Consumers
Power
Company

RE: Midland OM-OL Proceedings
Docket Nos. 50-329, 50-330

Attached are copies of reports of audits recently conducted by the Midland Project Quality Assurance Department, numbered as follows:

AUDIT TEAM LEADER/DATE: <i>D. D. Cochran 12/22/81</i>	APPROVED BY/DATE: <i>M. J. Schaffer 12/23/81</i>	AUDIT NO: M-01-306-1 ✓
		FILE NUMBER: 18.4.3.4 and 18.4.3.6
		DATE OF AUDIT: Nov 20 - Dec 2, 1981
		ORGANIZATION AUDITED: Bechtel Const/QC
PLANT & PROJECT: Midland 1 and 2

DETAIL 22B

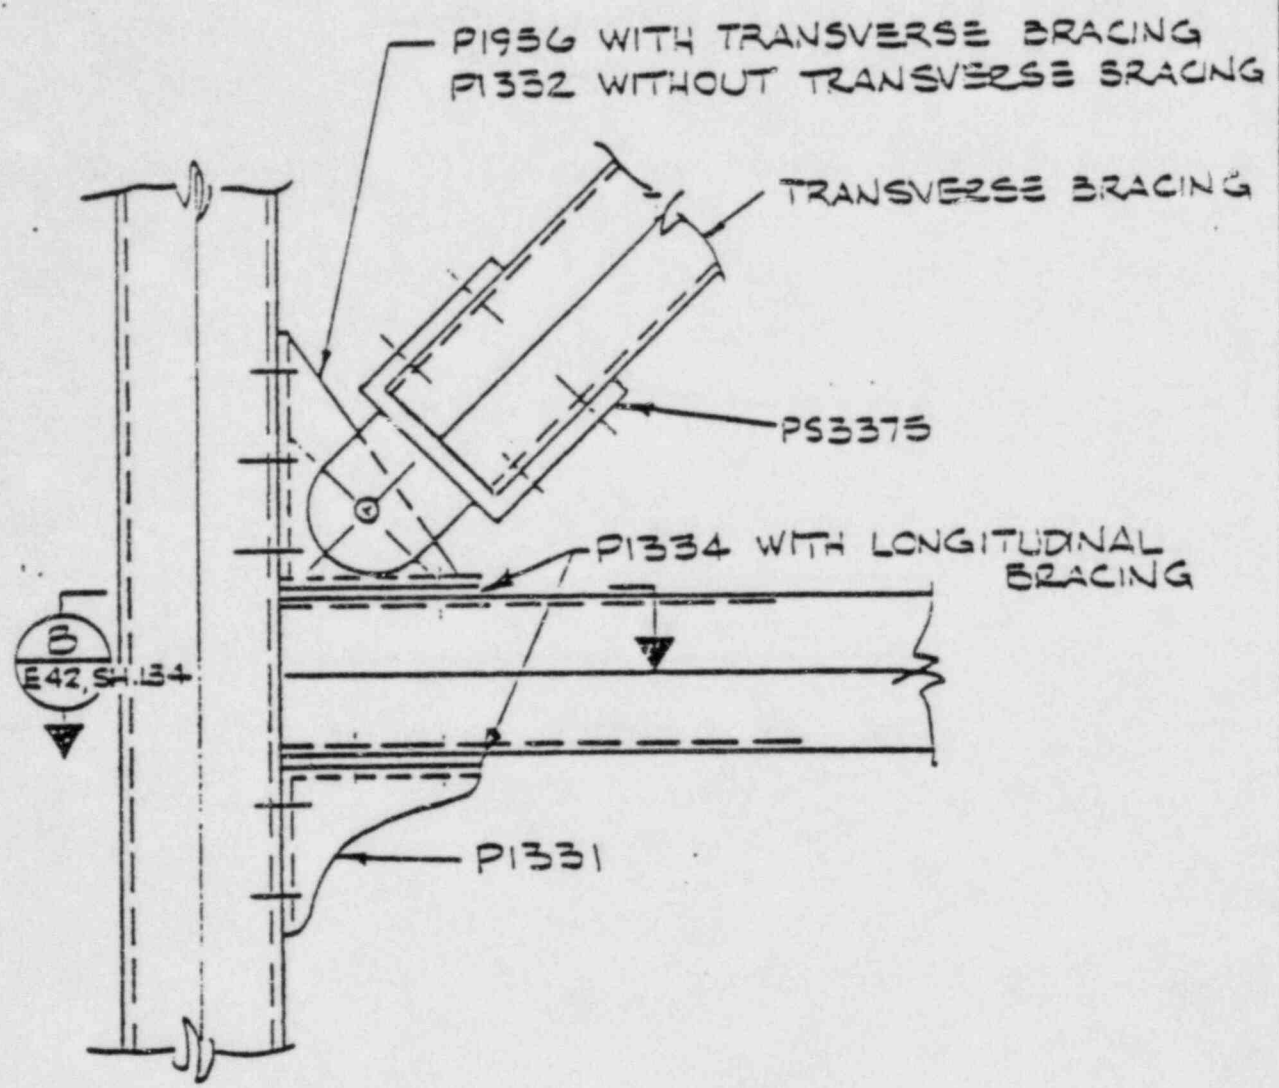
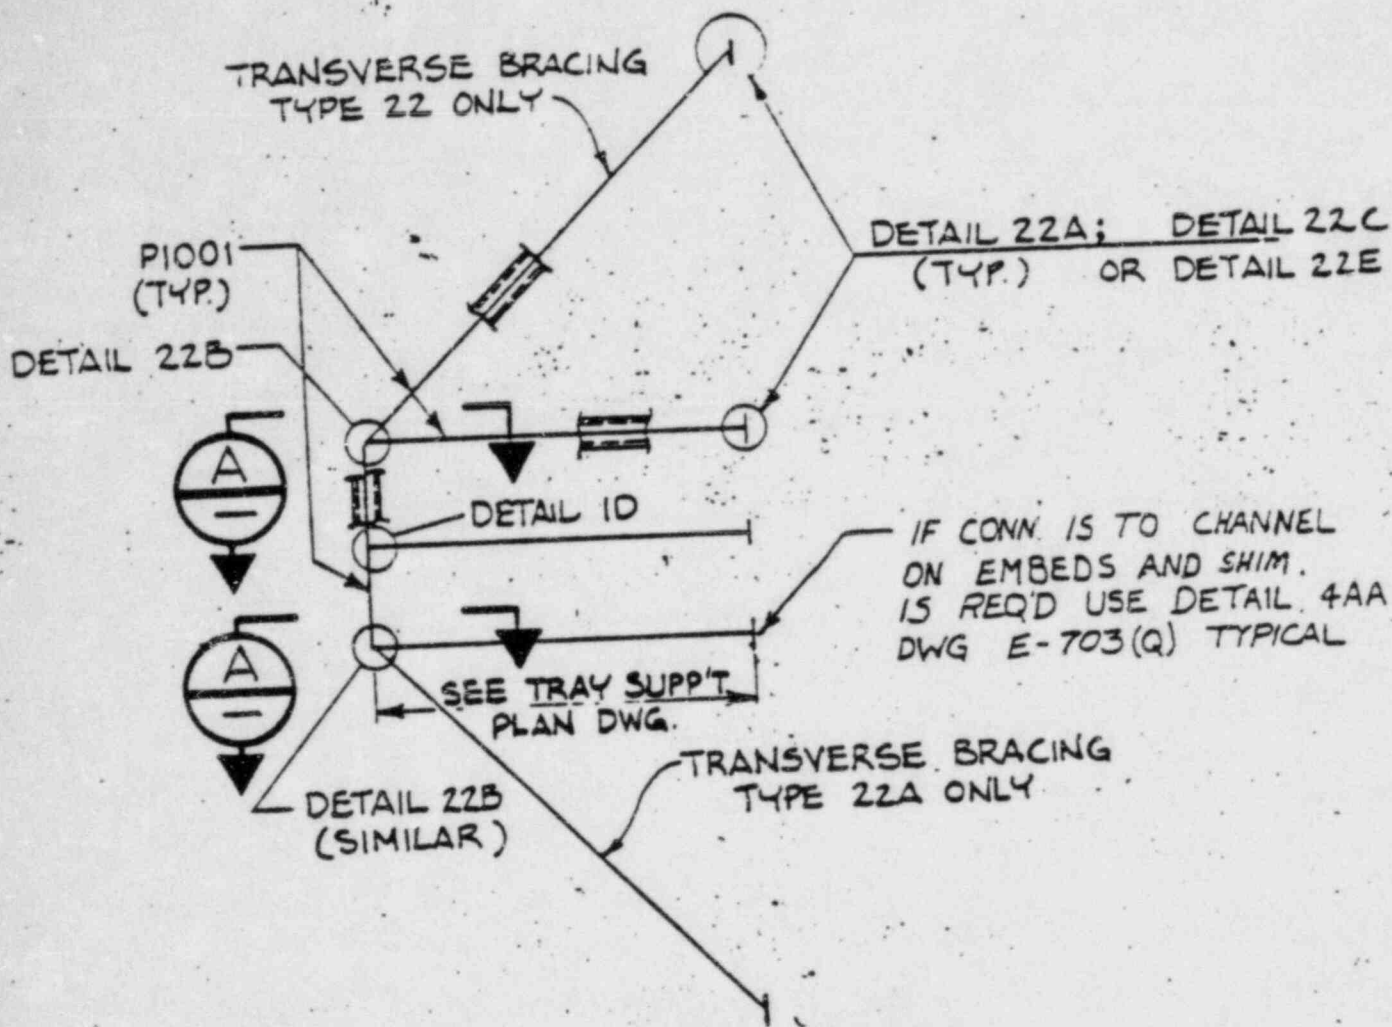
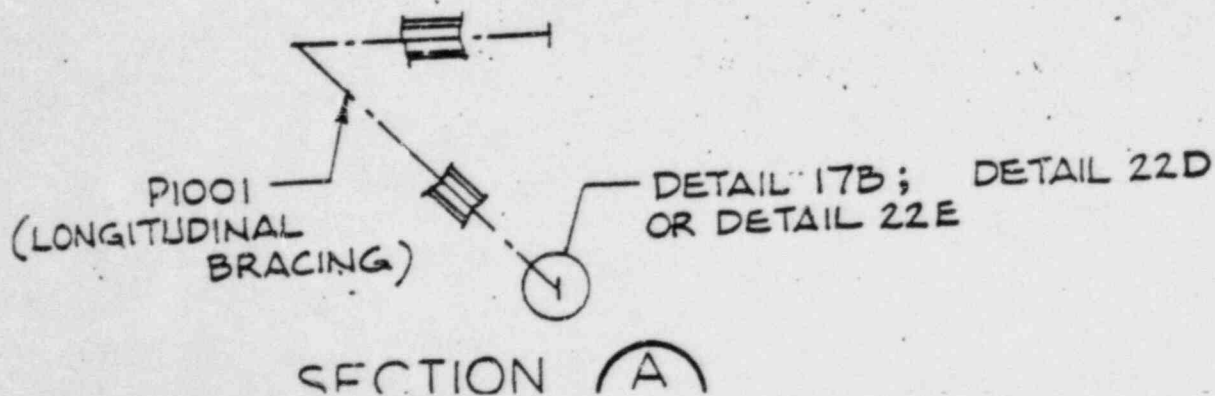
Dwg 7220-E-42(Q) Sh 133, Rev 0, Detail 22B (attached) show the required bracing for a Type 22 or 22A Tray Support.

METHOD OF VERIFICATION:
Visual Inspection to verify installation of shelf bracket.

**FIGURE 1-1
CONSTRUCTION COMPLETION PROGRAM SCHEMATIC**

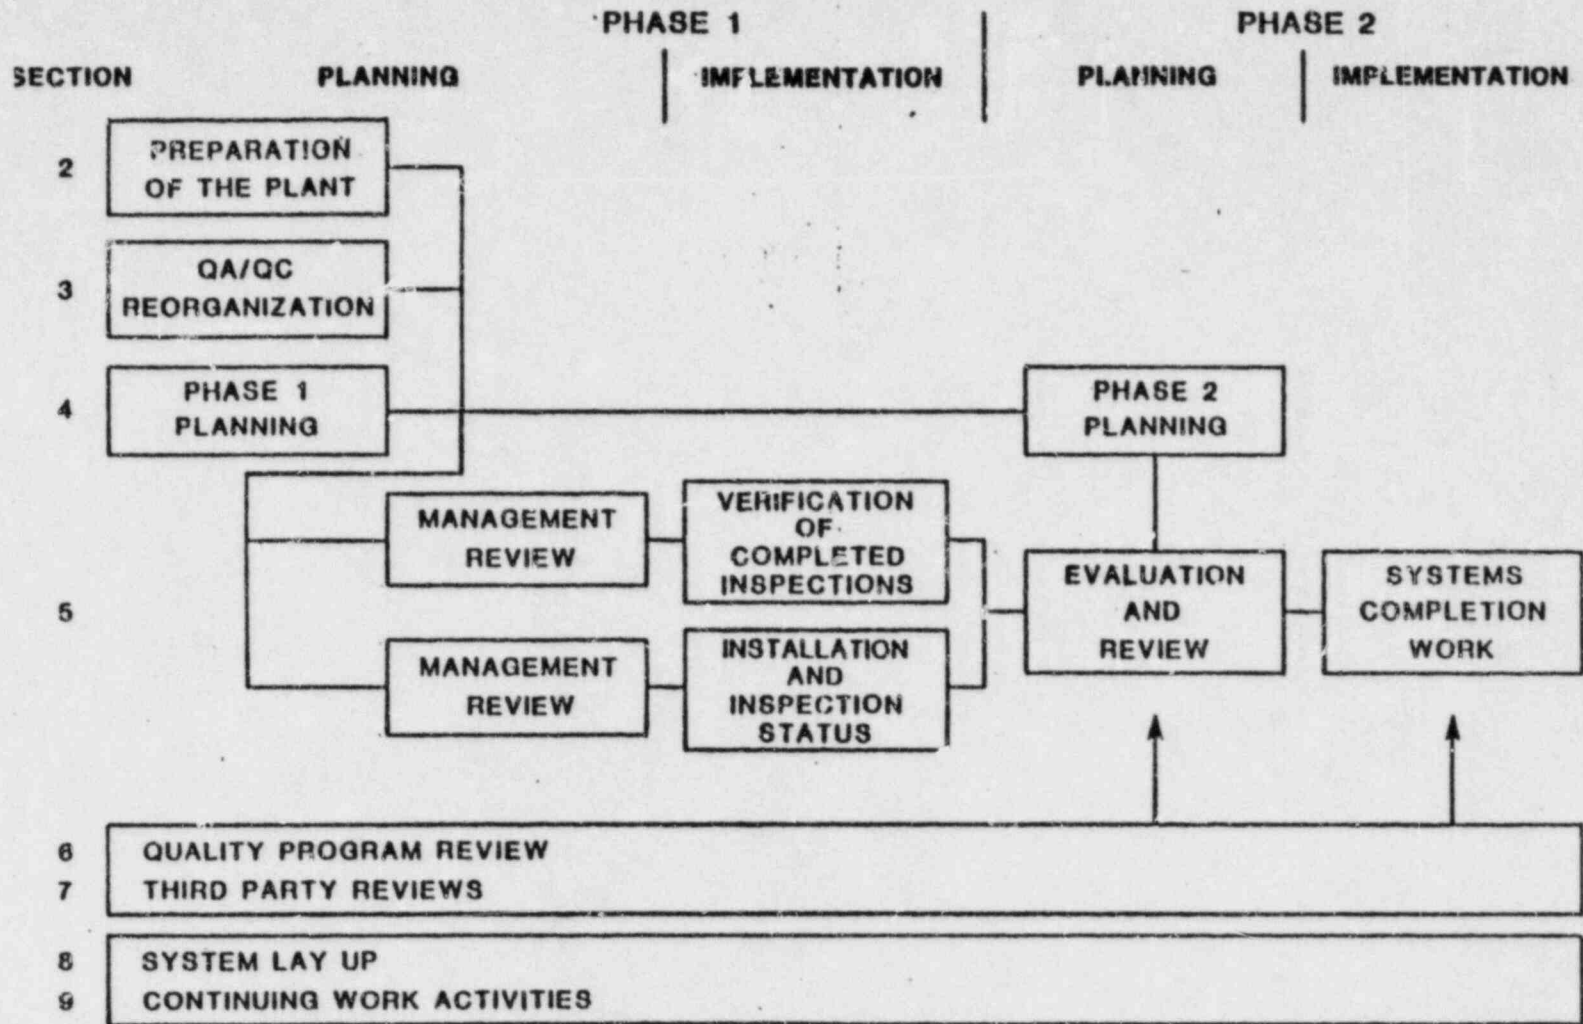
Miller - Figure 1-1
